B1372 NAPS UPGRADE

SUPPLEMENTAL TECHNICAL REQUIREMENTS

Contents

FIRE ALARM CONTROL PANEL
AND PA SYSTEM PANEL
SKETCH 01 OF 01

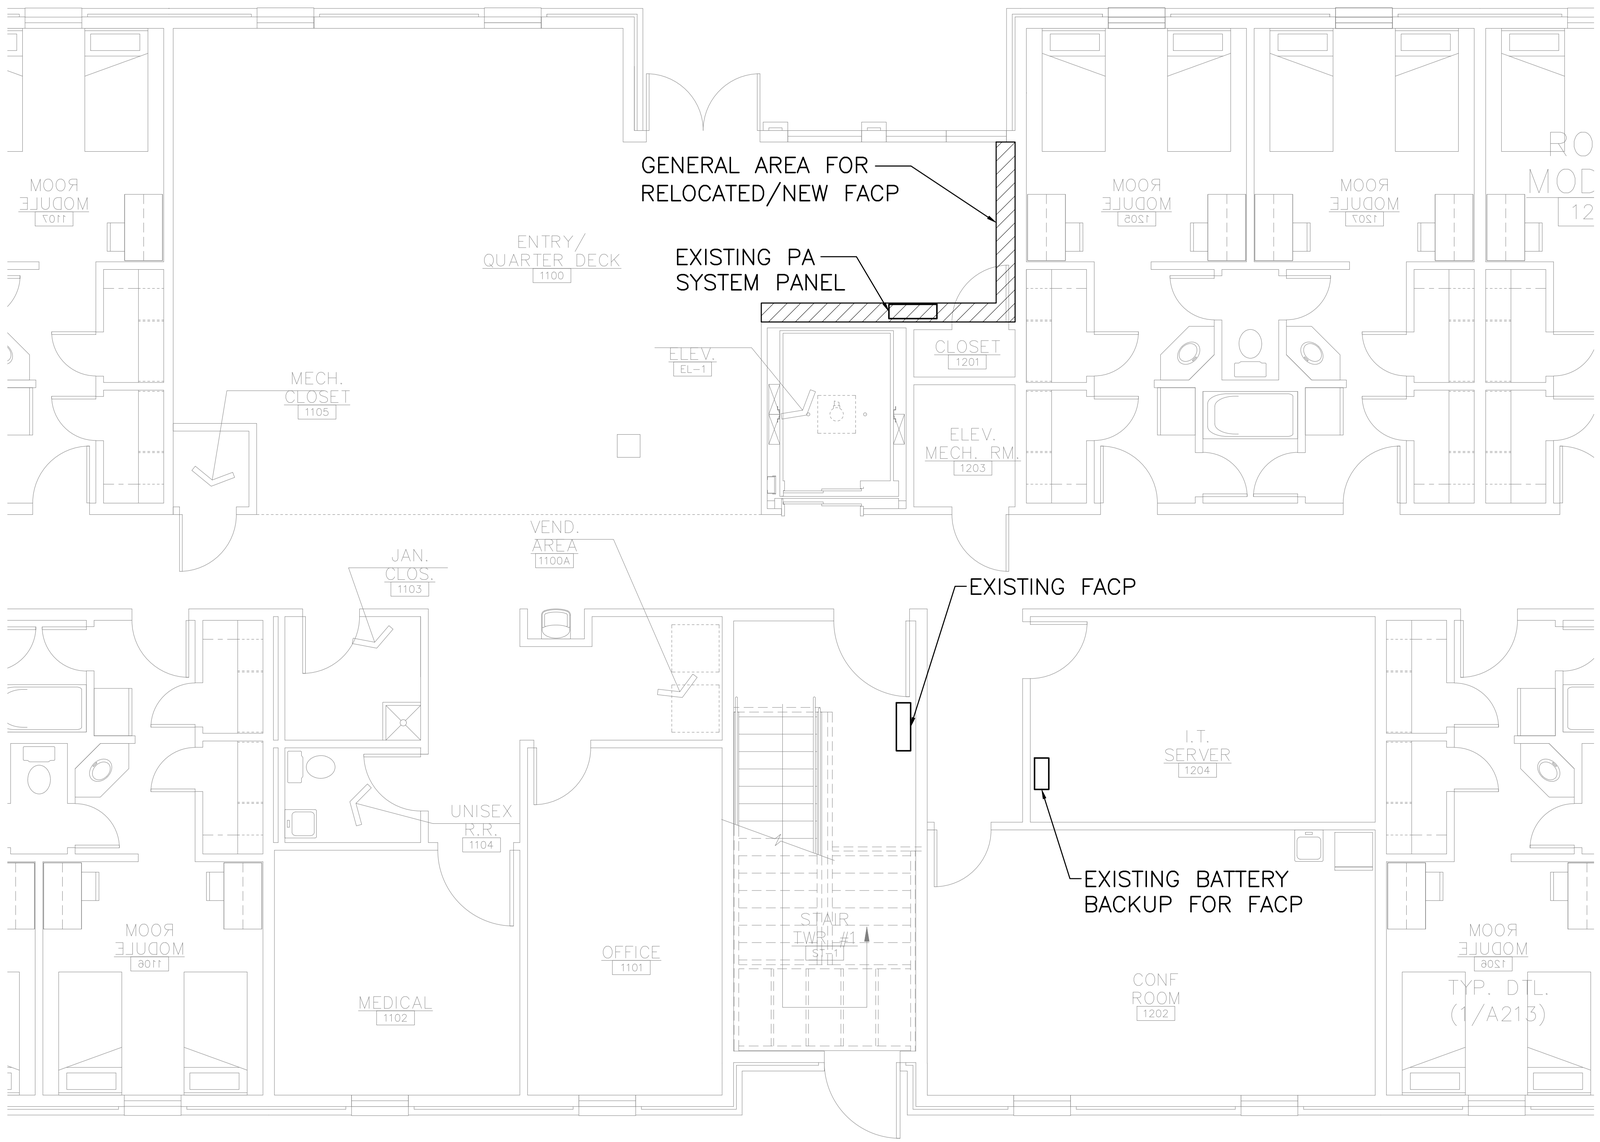
- (Base bid): **Relocate** existing Simplex FACP from south stairwell to the Quarterdeck area next to Simplex PA panel. Reconnect to PA Panel.
    - Convert the existing FACP location into a large junction box (JB).

- Recommission the Fire Alarm System for full functionality.
- (Base Bid) Replace smoke detectors in berthing spaces (174).
- (Option) Provide a **new** FACP and locate the new panel in the Quarterdeck area, adjacent to the Simplex PA panel on the east end of the Quarterdeck area. Connect the new FACP to the existing Simplex PA panel.

ATT-2 REV1

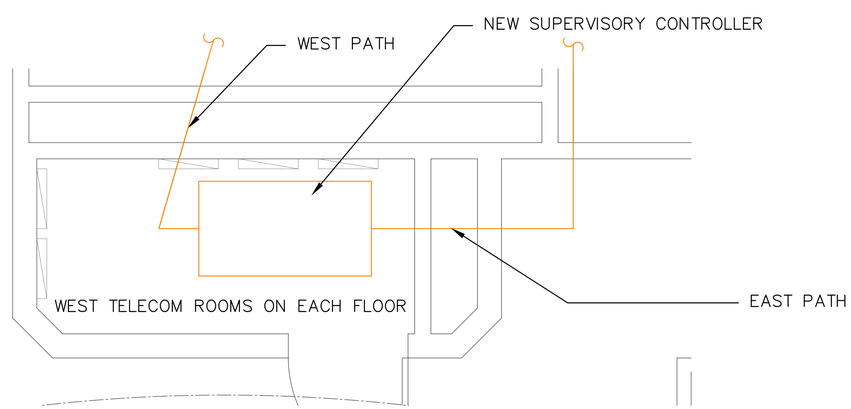
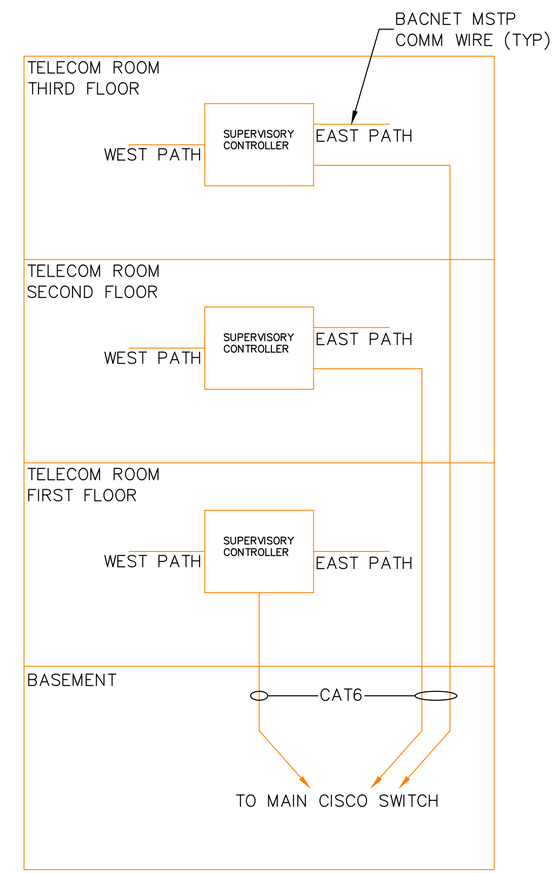
- Refer to revised drawing ATT-2 REV1 issued by amendment.
- Direct Digital Controls (DDC) shall be a first-tier subcontractor to the prime contractor and shall not be affiliated with any other subcontractor.

1. MOUNT NEW SUPERVISORY CONTROLLERS IN TELECOM ROOMS.
2. DETAIL SHOWN BELOW IS TYPICAL FOR ALL 3 FLOORS REPRESENTING SUGGESTED NEW CABLE PATHWAYS TO NEW THERMOSTATS.
3. DIFFERENCE IN NUMBER OF THERMOSTATS PER PATHWAY (EAST AND WEST) NOT TO EXCEED 5.
4. SEE ATTACHMENT 1A, 1B, 1C FOR NEW CABLE PATHWAYS THROUGHOUT EACH FLOOR.
5. PROVIDE 3 NEW JCI SNE 220 SUPERVISORY CONTROLLERS IN LOCKABLE CABINETS (ONE PER FLOOR) WITH 120V POWER AND 24V TRANSFORMER.
